EI-50, 03/25/2014

DISCUSSION ON OVERLAYS.

SKETCH. PROPOSAL FOR CHANGES.

Rolls-Royce
Motor Cars Limited

ABSTRACT PART 1: RELATIVE SIZE COMPARISON.

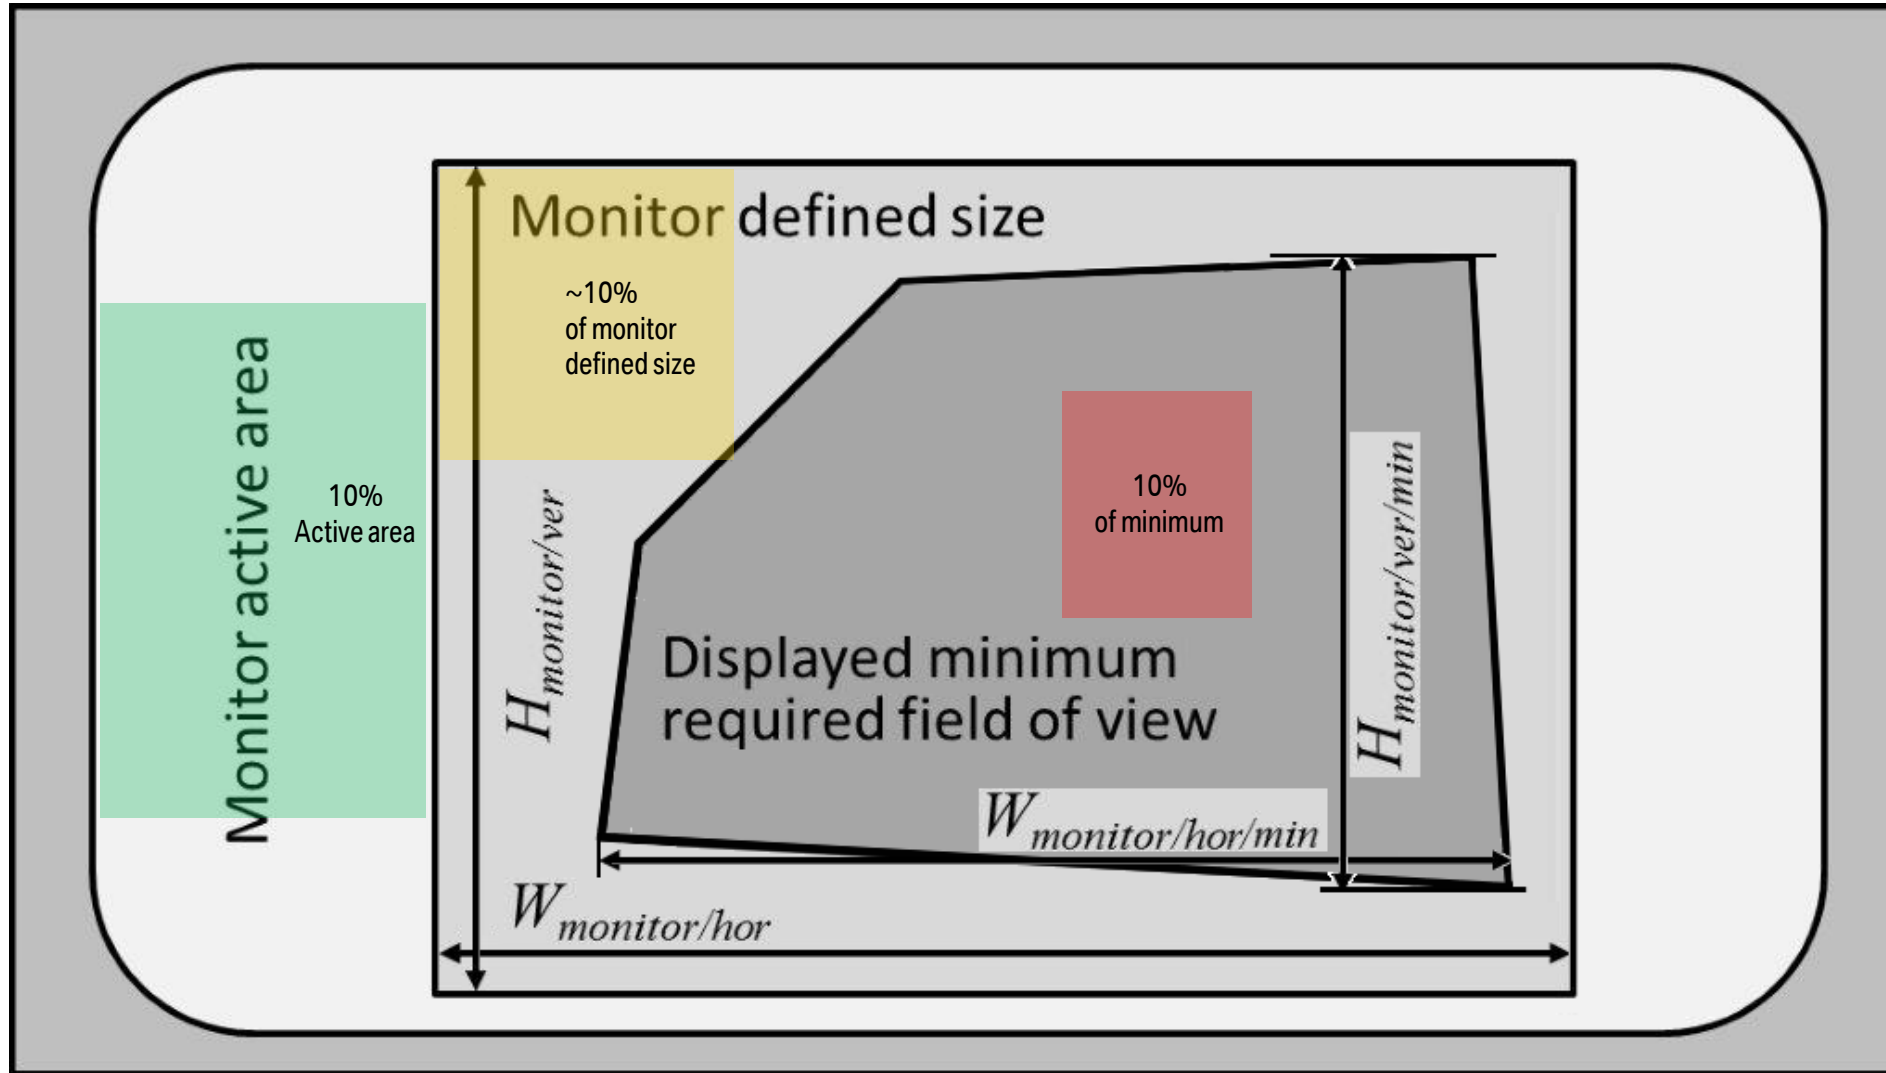
1. **Green Overlay** is of a transparency of 70% and 10% of the active area of the monitor.

2. **Yellow Overlay** is of a transparency of 70% and 10% of the monitor defined size.

3. **Red Overlay** is of a transparency of 70% and 10% of the minimum required field of view.

QUESTION 1. HOW MUCH IN WHICH AREA?

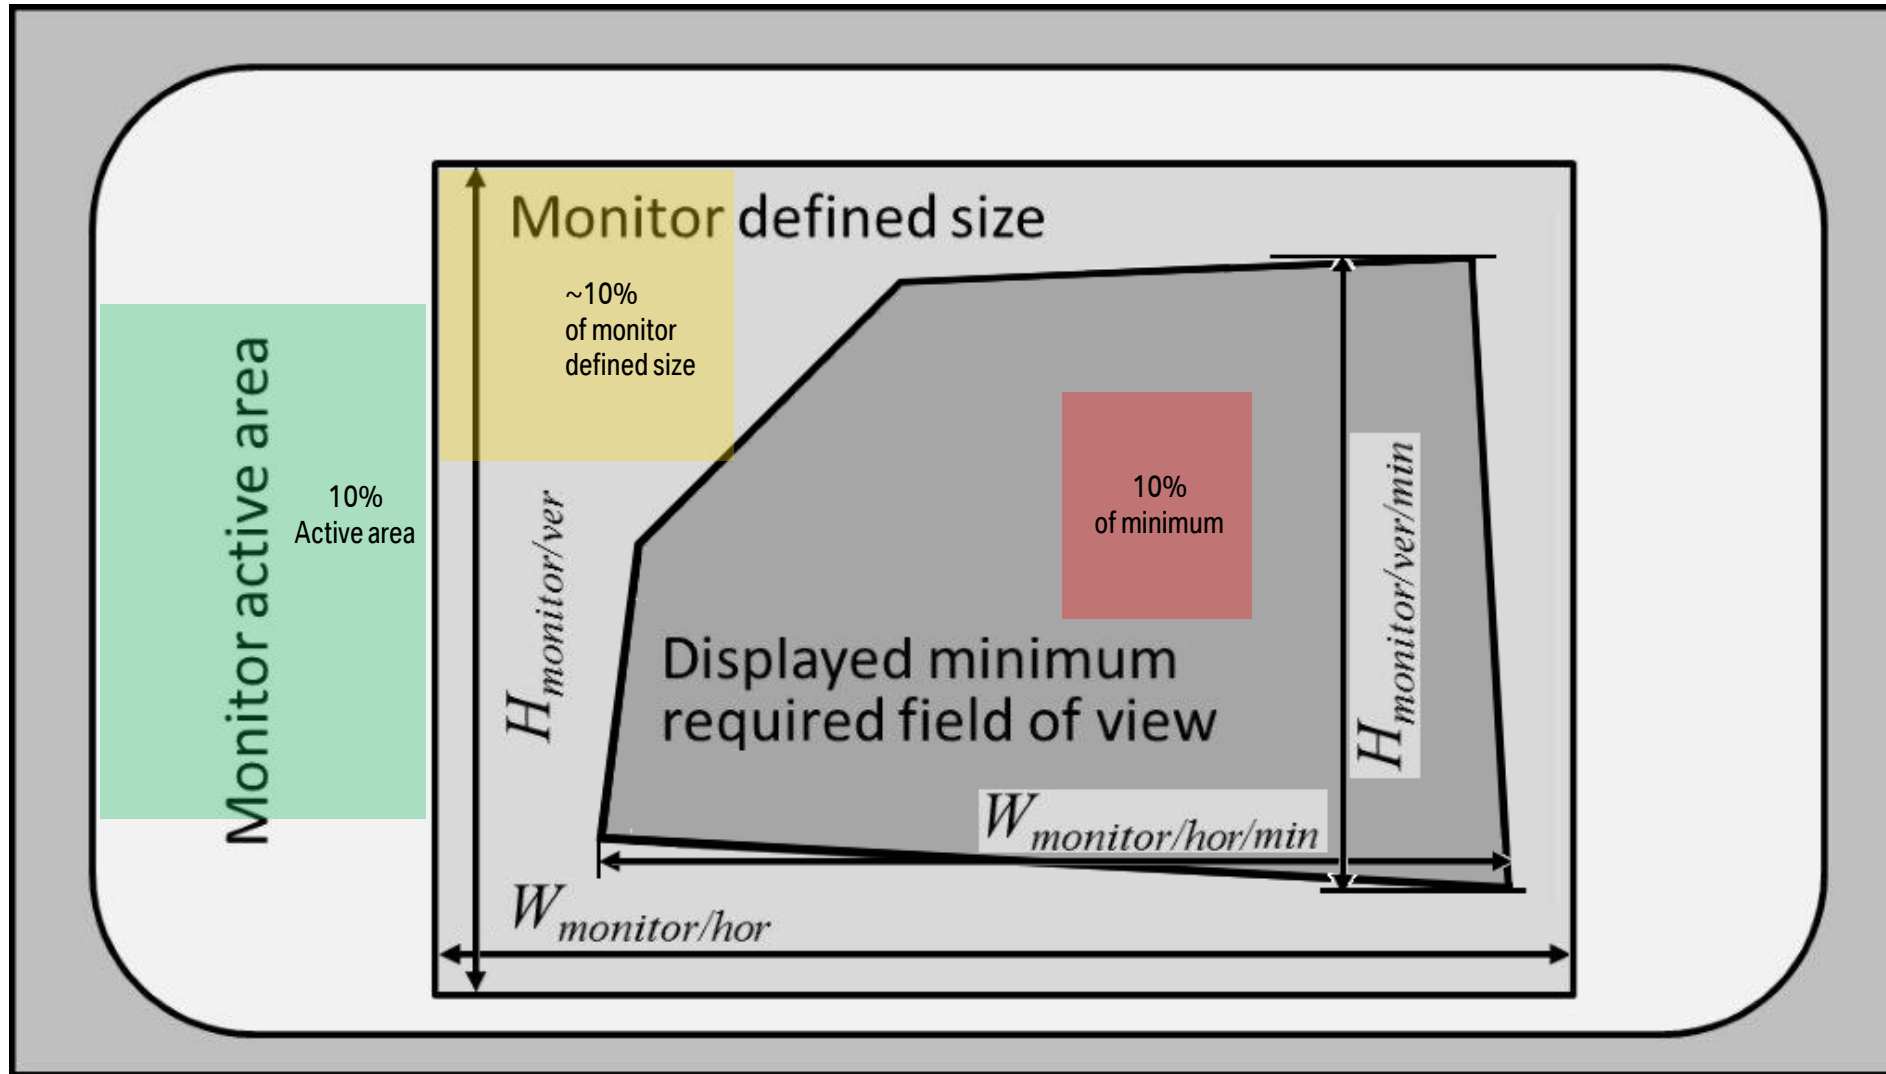
All three types **allowed** at the same time ?

QUESTION 2. OVERALL SIZE?

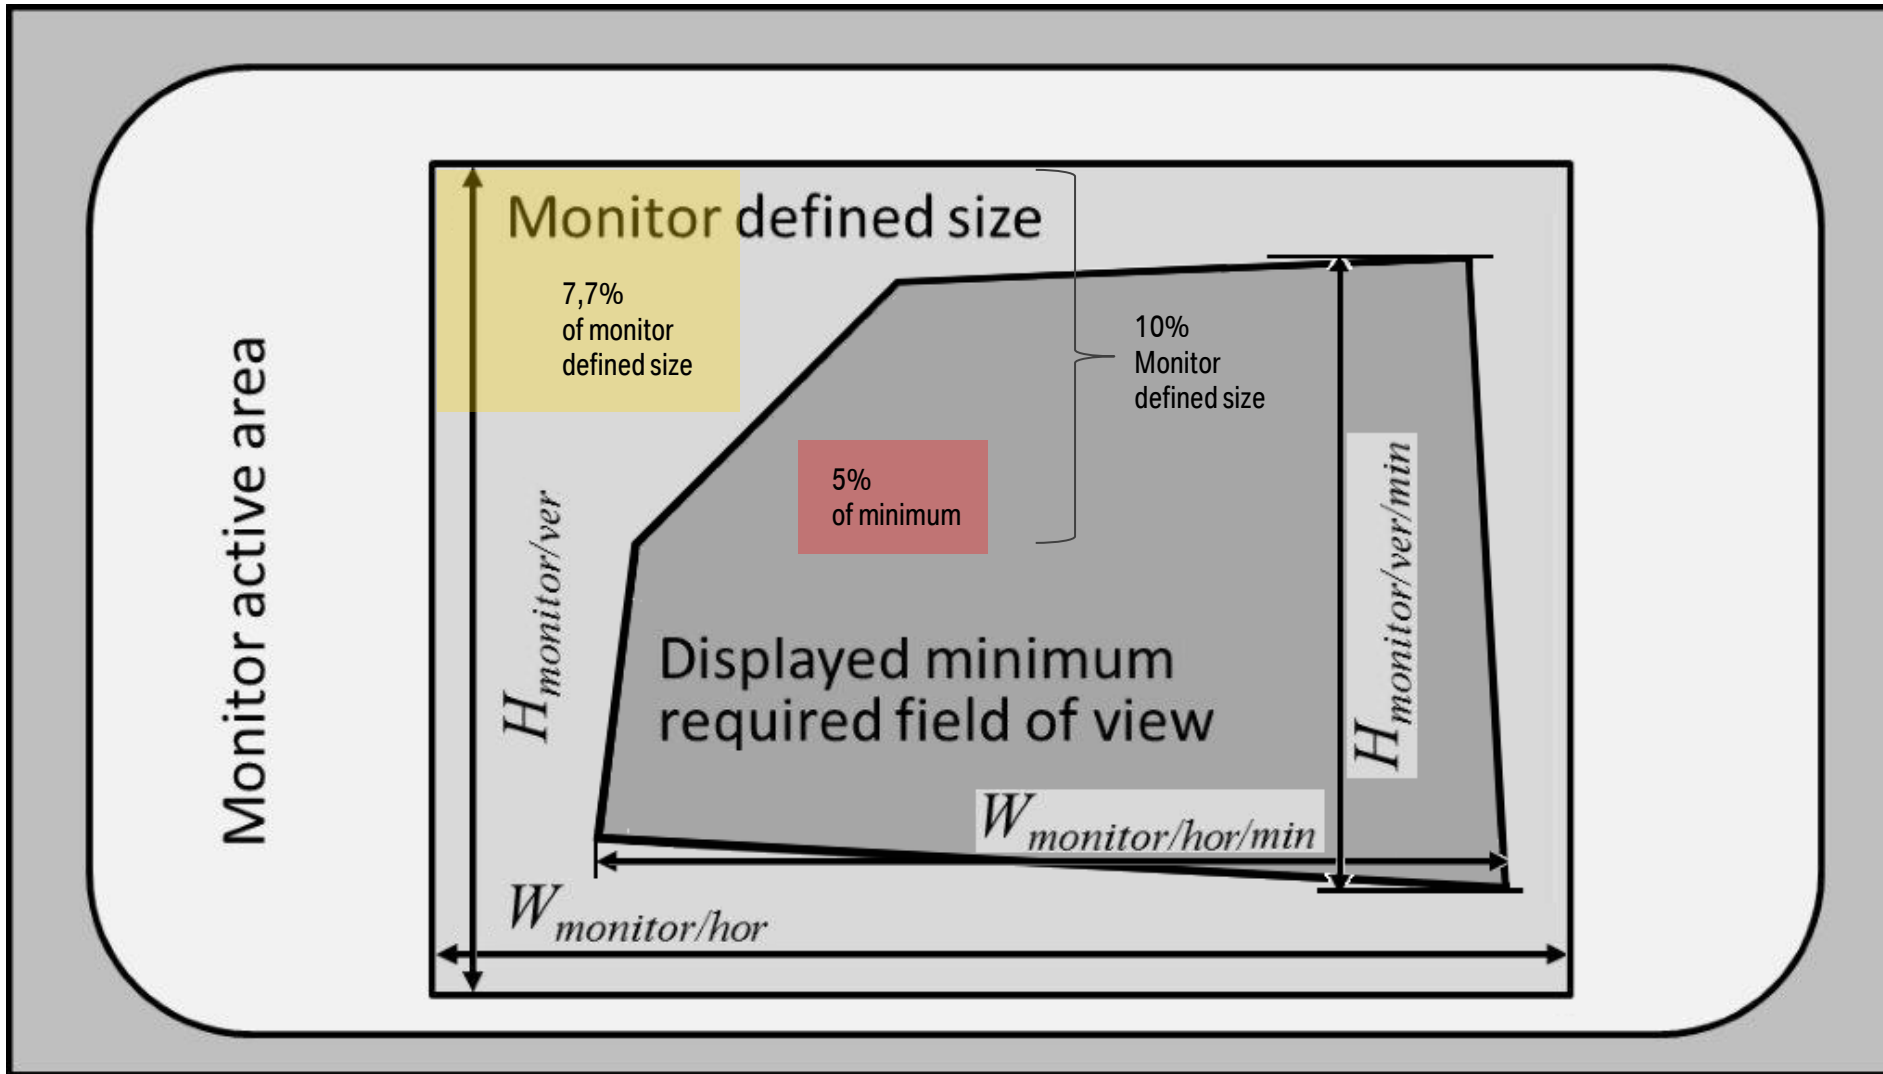
Two types **allowed** with **in total 10%** of monitor defined size at the same time?

EXAMPLES FOR OVERLAYS. WITHIN THE DEFINED SIZE.

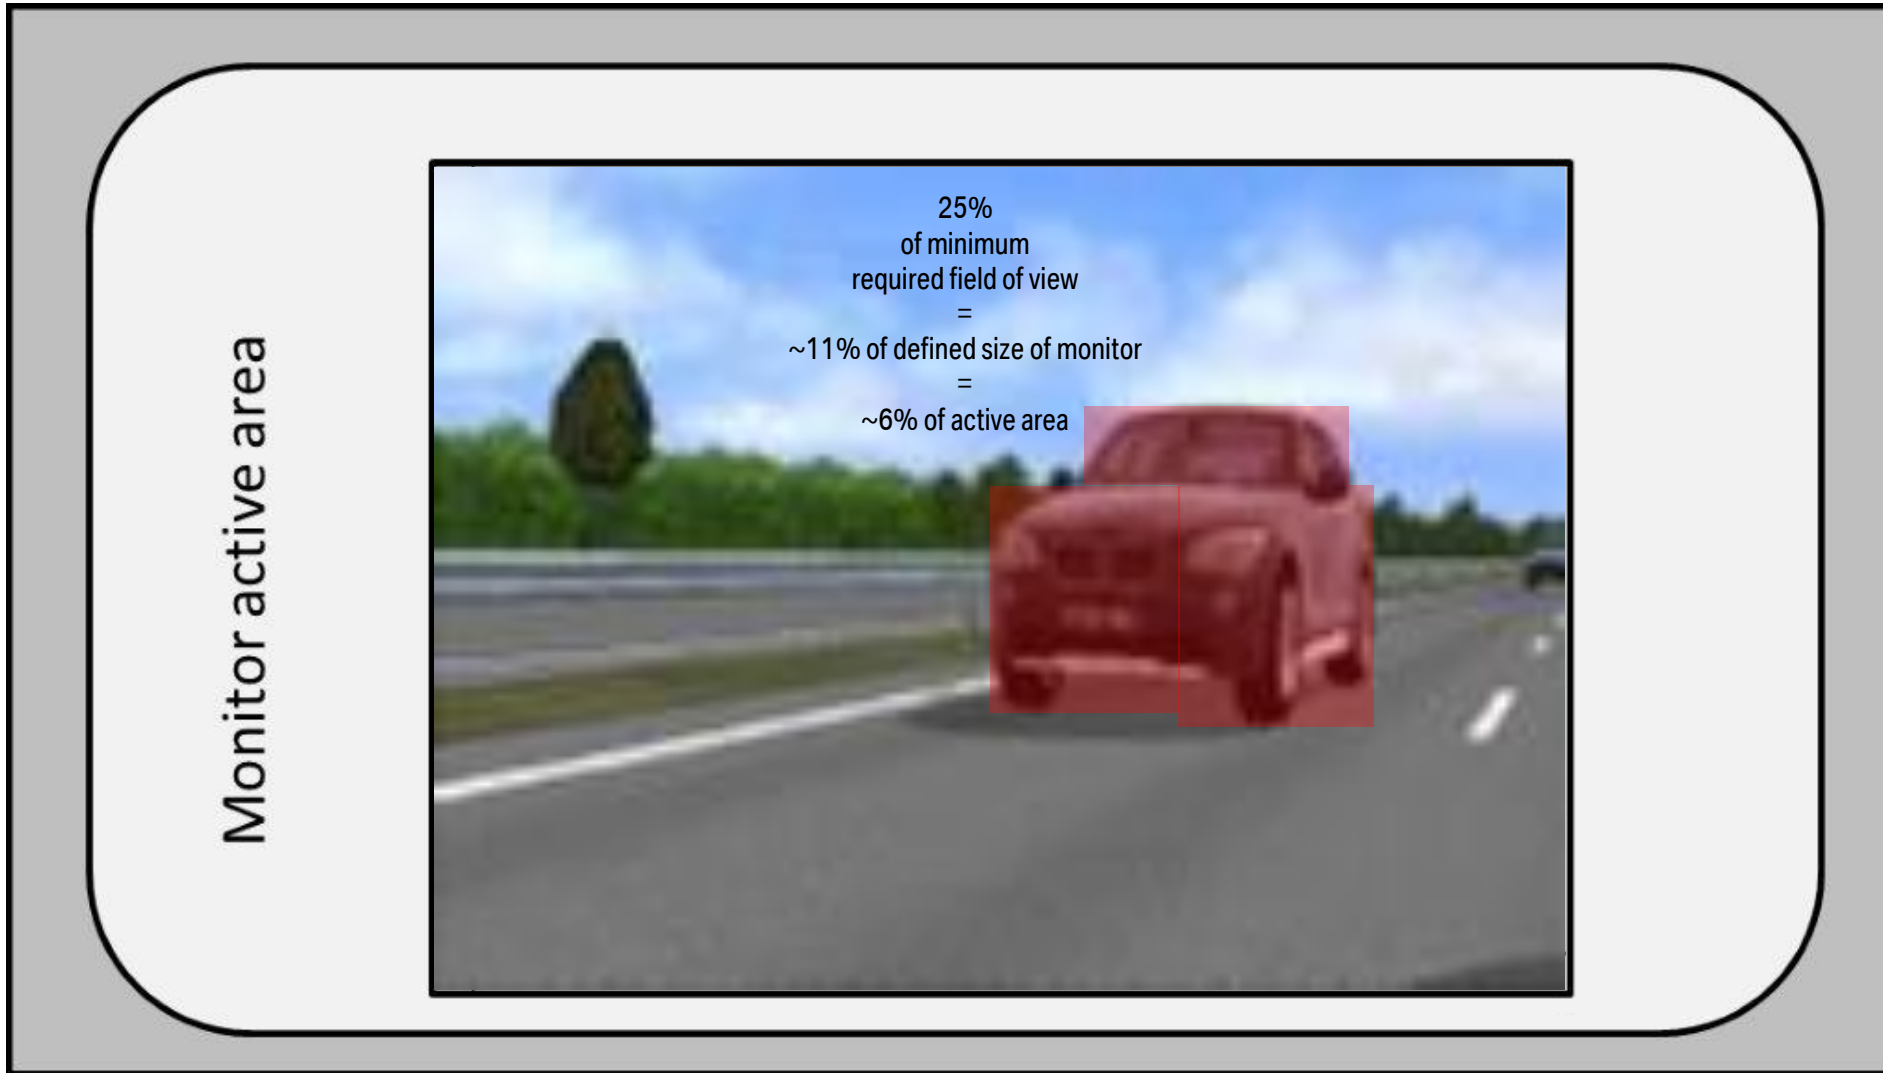
Are those 10% transparent overlay in the monitor defined size **allowed**?
